**SUBMISSIONS TO THE DRAFT EIA REPORT FOR THE PROPOSED GAS TO POWER PROJECT
AT THE PORT OF SALDANHA BAY**

DFFE REF NO: 14/12/16/3/3/2/2006

These submissions are made by Green Connection and Natural Justice in response to the 2022 Draft EIA report published for comment by Karpowership SA (PTY) LTD for the Gas to Power Via Powerships Project (referred to hereafter as the Karpowership project) for the port of Saldanha Bay.

Figure 4-14 Noise Sensitive Areas

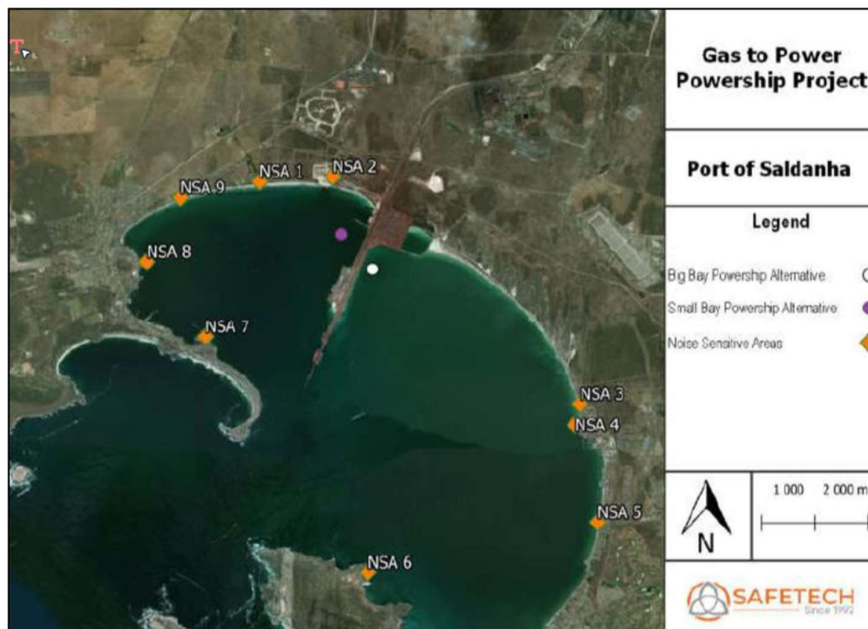
13. It follows from the above that the issue of operational above ground noise needed to be assessed and mitigated for compliance with the 2014 EIA regulations.
14. Noise assessment modelling in the 2021 DEIA report predicted substantial violations of noise standards at a number of points around the bay. The EIA report evaluated nine noise-sensitive areas (NSAs) and modelled ambient noise levels during the operations phase of the project. It should be noted that this is not a temporary issue: A minimum 20-year lifespan is required under the terms of the RMIPPPP,¹¹ and the powership's operational lifespan is 25 years.
15. These models are based on two possible powership locations; unfortunately, the numbering of these alternatives is not consistent (see 2021 EIAR p42). The preferred location is in Big Bay (white circle), with the alternative location in Small Bay (blue circle).¹²

16. This data clearly indicates exceedances of noise limits at the Industrial site at NSA 2 (approximately the Oil Spill Response Limited facility), the “Residential” NSA site 1 (approximately at Blue Bay Lodge), the “Residential” NSA site 9 at Saldanha Beach, and the “Residential” site NSA 7 approximately at the site of the Small-craft Harbour on the breakwater. (Ambient noise levels below 40 dB(A) are reported as “0.0”.) Although the Small Bay location was first proposed, the Big Bay location is now preferred, and due to distance and the presence of the jetty, has somewhat lower noise levels at most NSAs. Still, the noise limits at some points along the shore of Small Bay suffer noise levels exceeding night-time standards and bordering on daytime standards.

23. Dramatically different noise modelling results from the 2021 (left) and 2022 (right) EIARs.

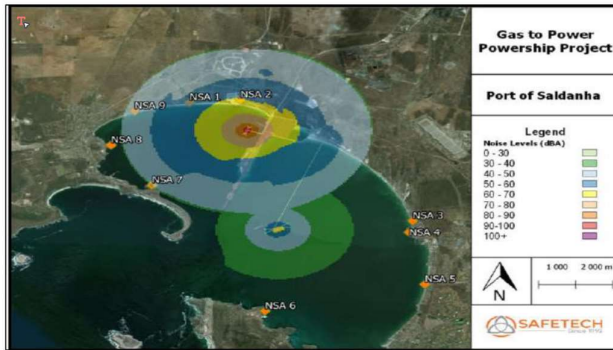
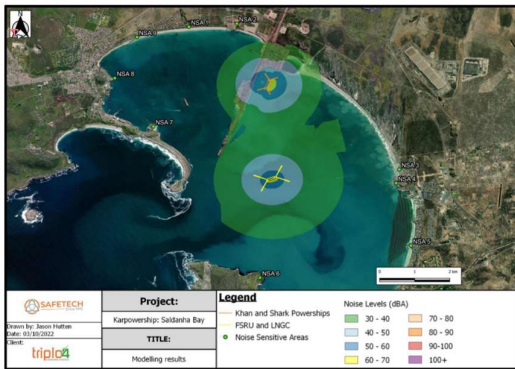
22. This dramatic decrease in modelled noise is at odds with the results of 2021, and is hard to explain. The 2021 assessment included modelled noise levels for the Big Bay location as “Alternative 2” (table above). Although these are lower than the Small Bay location, they greatly exceed the night limit at NSA 1 (the Blue Bay Lodge), as well as at NSA 7 (on the breakwater). The much lower overall noise levels represented in the 2022 EIAR are not consistent with this data. Rather than the detailed modelling by NSA presented in the 2021 assessment, the 2022 assessment merely contains the phrase, “the noise impact associated with the operational activities of the proposed Project is predicted to be of Low significance after mitigation at the Port of Saldanha.” More detailed modelling is relegated to the appendix. Similarly, the overall metric “Impact on the sense of place experienced by the local community as a result of visual and noise effects that appear during the operational phase” is listed simply as “Low”.

Appendix 1.5 - Preferred Powership and FSRU location _ Gas Pipeline Alternatives.pdf

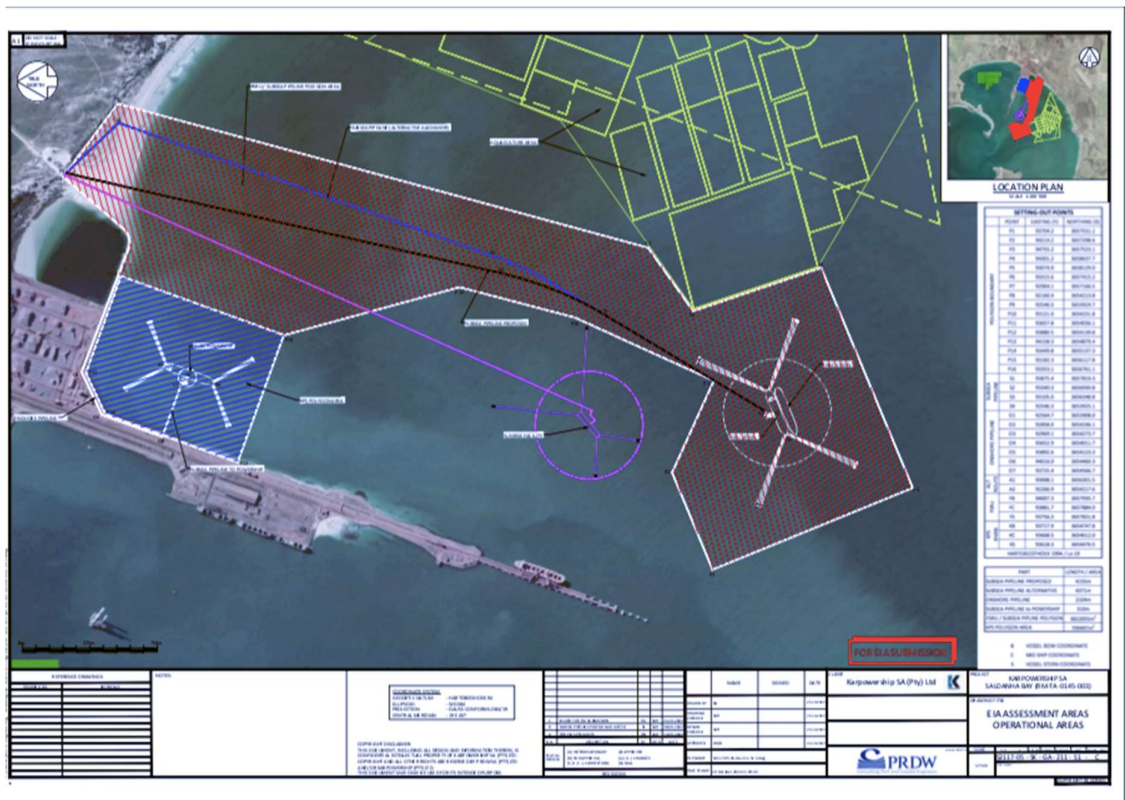
85. The preferred location of the Karpowership FSRU and associated pipelines appears from diagrams in the 2022 DEIA report.⁶⁷ Diagrams from the Anchor 2022 Aquaculture report show that this location is in an area where extensive underwater reefs exist, that require protection and that provide important ecosystem and socio-economic benefits. The Anchor 2022 Aquaculture report states that initial estimates of the extent of reefs was probably conservative and more research is required to determine their extent.⁶⁸

Position of underwater reefs per the **SALDANHA BAY SEA BASED AQUACULTURE DEVELOPMENT ZONE SPECIALIST ENVIRONMENTAL MONITORING HARD SUBSTRATE SURVEY August 2022** (Anchor 2022)

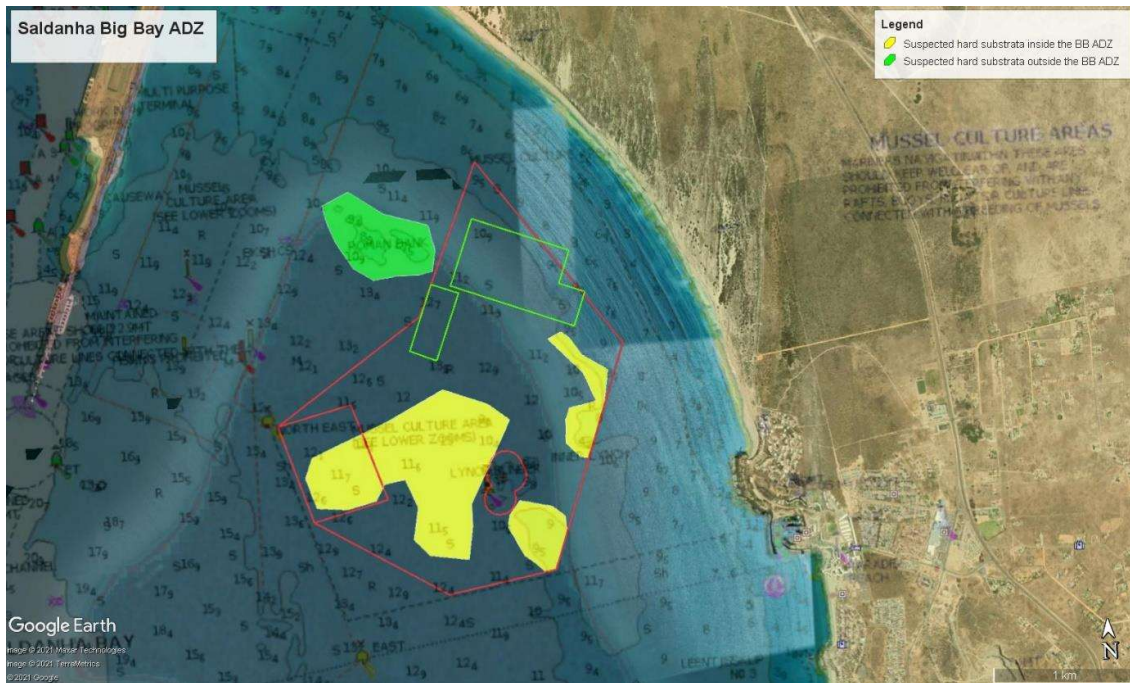
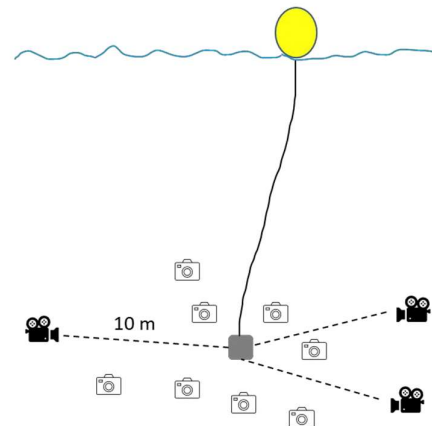
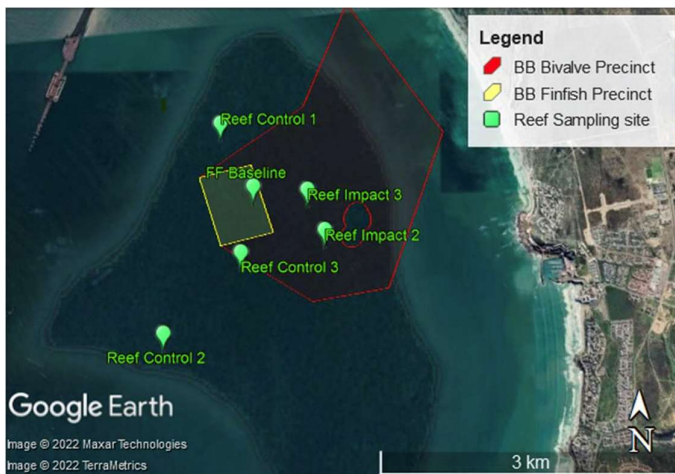
The first photograph below indicates the estimated reef areas in yellow and green. The second photograph indicates the finfish precinct in red and the bivalve precinct in yellow. From a comparison with the preferred location diagram above it is clear that the FSRU will be located directly above a hard substrata (reef) and finfish precinct and its pipelines will traverse this reef, as well as a second reef indicated in green, closer to shore. It will cross the finfish and bivalve precincts.

87. The Marine report states that disturbance to benthic and littoral habitats and fauna is an unavoidable consequence of the proposed development. However, disturbance to potentially sensitive habitats should be minimised. Avoidance of destruction of the reef by the laying of pipelines was recommended in the Marine expert report, and is the basis for a recommendation of **low** impact in the final Draft EIA report.

Figure 1- Narrow band frequency plot of a 15-minute sample taken from Richards Bay (Background Noise Monitoring). Yellow line indicates noise levels during a vessel passage, blue line indicates natural sound levels.

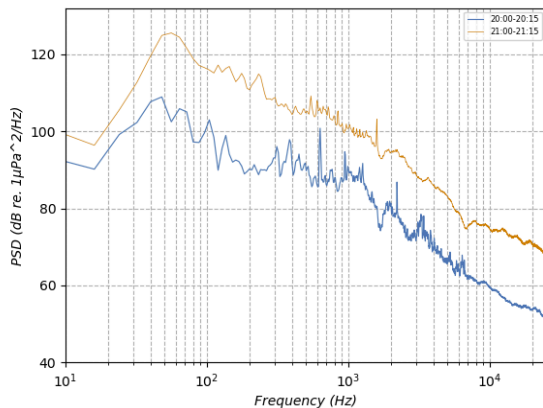
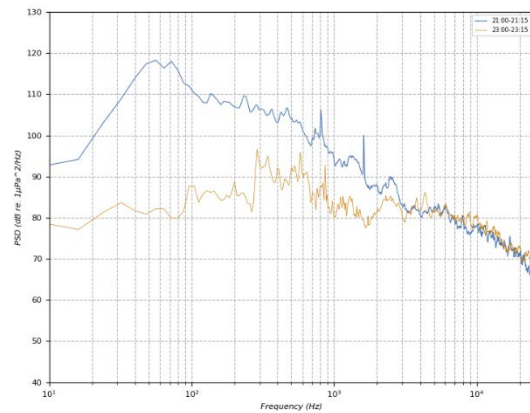
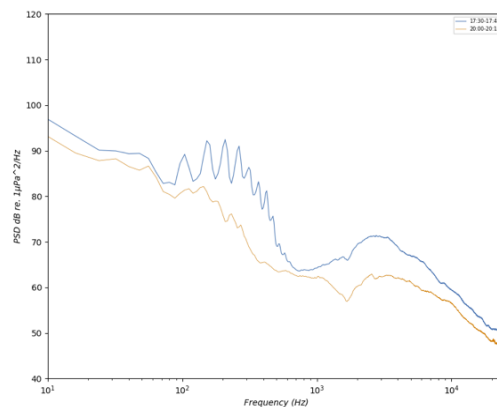
When the studies claim that a baseline is “natural” when it is in fact inflated due to the presence of vessels and associated activities, this has the effect of minimizing our perception of the noise impacts associated with the powership projects. This is problematic because the increases in sound associated with the project are in fact quite significant. Reminding the reader that decibels are logarithmic, **a 10 dB increase in ambient noise is indicative of noise levels that are 10 times the intensity, while a 30 increase is 1000 times the sound intensity.** The increases in the soundscape generated by the powerships are therefore without a doubt ecologically meaningful.
